Access Compliance Report

Public Rights-of-Way

(Curb Ramps)

Intersection ID: 15317	Main Street: FOSTER_AV	Cross Street: NEW_BERN_ST	Location: S
ADA ID: 4D6C519BFAC8	Ramp Type: Perp	Initial Pass/Fail: Pass	Overall Compliance: No
		Severity Score: 0

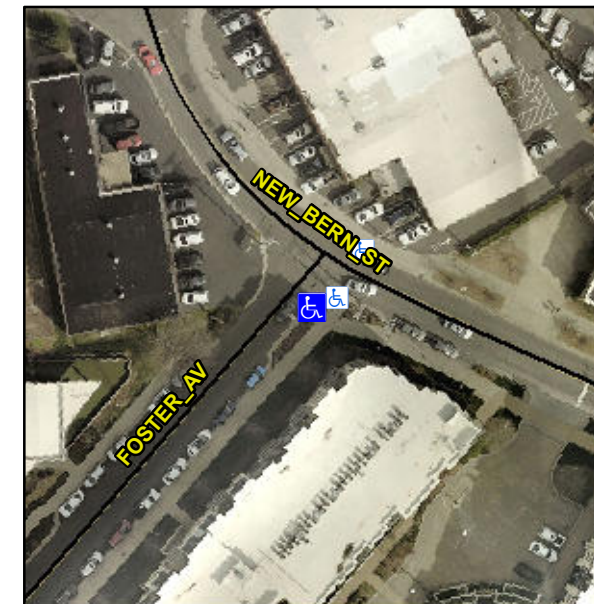
**Remove & Replace Entire Ramp.
Remove & Replace Gutter.**

Not Found, R304.2.2-Perp, R304.3.2-Para, R304.5.3
